Proposal for draft Corrigendum 2 to Revision 2 of Regulation N°44

A. PROPOSAL

Figure 1

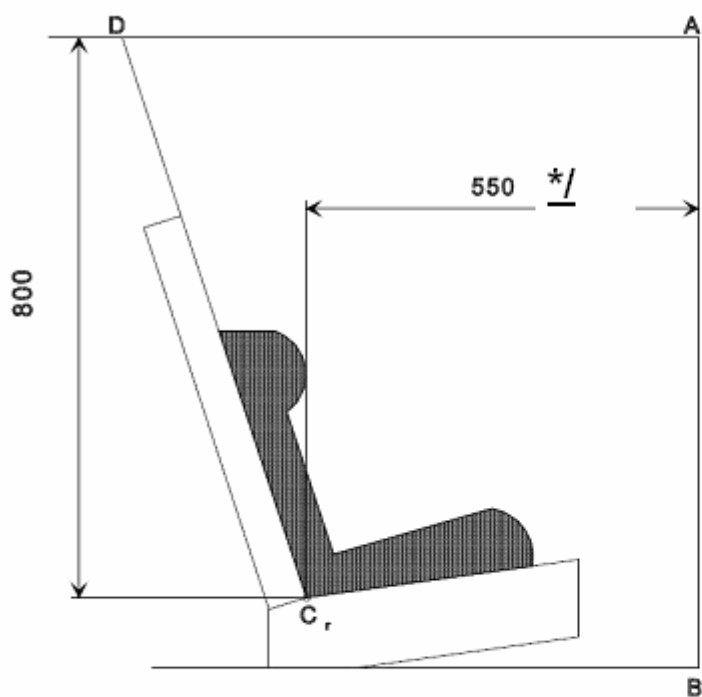
Paragraph 7.1.4.4.1.1., add the footnote at the 550 dimension in Figure 1 :

***/ For the purpose of the test specified in paragraph 7.1.4.1.10.1.1., this dimension shall be 500 mm.**

"5/ For the purpose of the test specified in paragraph 7.1.4.1.10.1.1., this dimension shall be 500 mm."
